15 March 2022

RE: MTW-HVO LEMINGTON UNDERGROUND WATER STORAGE MODIFICATIONS (MP06_0261 MOD 7 AND SSD-6464 MOD 2) – RESPONSE TO ADDITIONAL INFORMATION REQUEST

Chart 1
Estimated Inflow and Recovery Rates at the LUG Bore

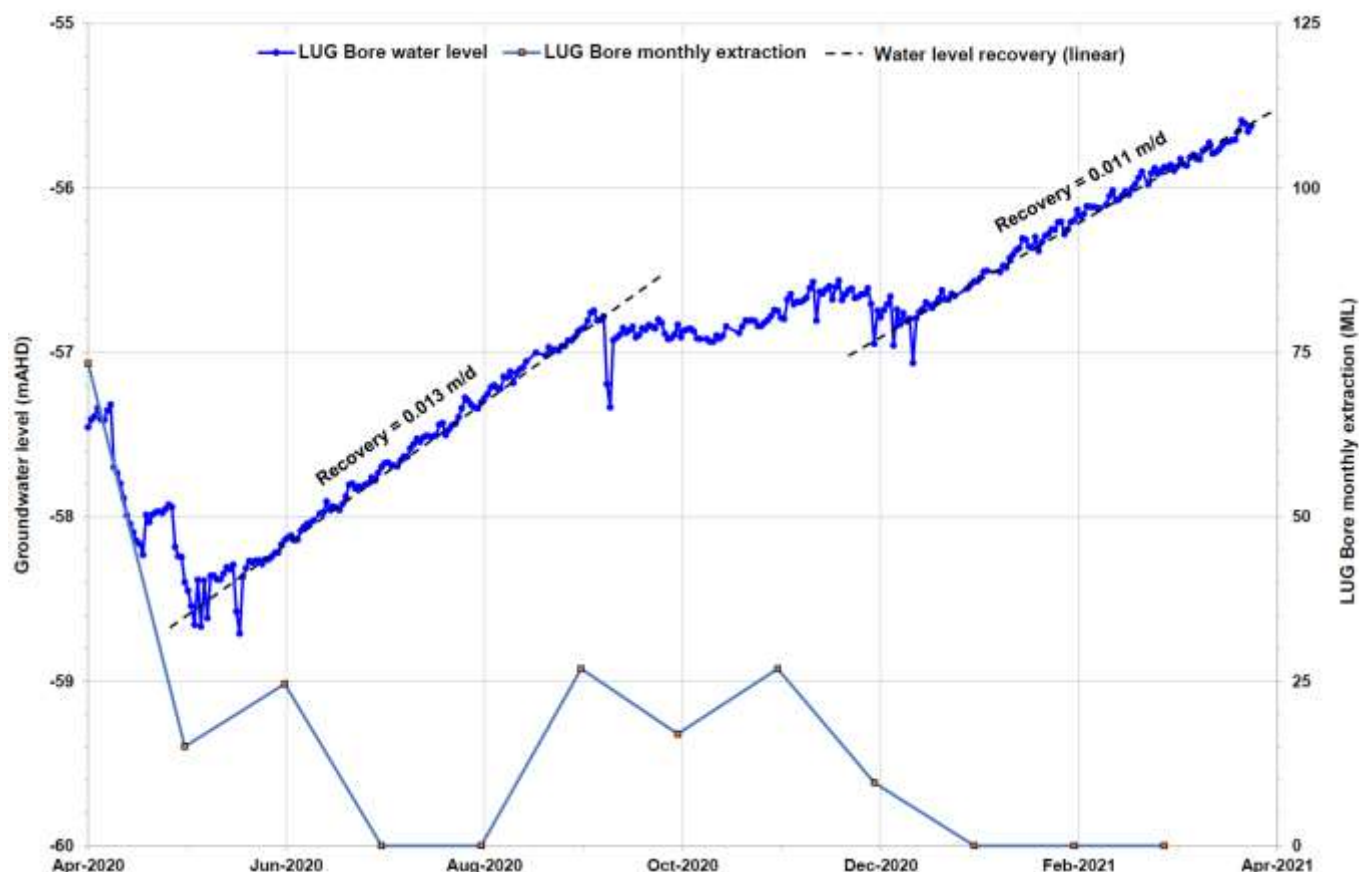
- *Quantify the maximum groundwater inflow into the Lemington Underground Void during the period water is to be stored and removed, and the ongoing maximum groundwater inflow after this is completed. The ability to acquire sufficient entitlement to account for the maximum predicted water take will need to be demonstrated.*

Groundwater inflows from the surrounding strata were estimated by Australasian Groundwater and Environmental Consultants Pty Ltd (AGE, 2021) in Section 5.6.2 of the Groundwater Assessment (Appendix A of the Modification Report) using measured groundwater level data at the LUG Bore during periods of no extraction. AGE (2021) estimated recovery rates of approximately 0.011 to 0.013 metres per day (Chart 1), which would be equivalent to inflows to the workings of approximately 500 megalitres per year.

Groundwater inflows would reduce as a result of storing Stored Water in the workings (as proposed by the Modification), or as the water level in the workings naturally recovers. This is due to the hydraulic gradient between the groundwater in the surrounding strata and the water in the workings being reduced. Accordingly, further groundwater modelling is not considered necessary.
